TECHNICAL INFORMATION

- Subject** ▶ Change of Link Plate, Center Washer and Center Plate
- For Models** ▶ BLS712, BLS820, LS0711B, LS711D, LS0711Z, LS0811, LS800D, DK2000, DK2401, DK2403
- Country** ▶ All countries
- Description** ▶ See below.

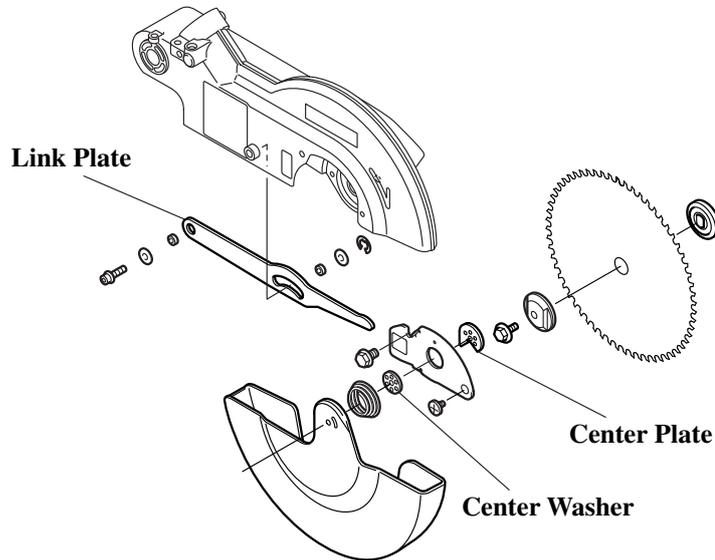
1. Shape of Link Plate has been modified as illustrated below.

Note: This modification applies to the models BLS712, LS0711B, LS711D and LS0711Z only. Link Plate for LS0811, BLS820 and LS800D have round end as they are now.

▶ Current	▶ New
Side view of top of Link Plate Straight	Side view of top of Link Plate Round
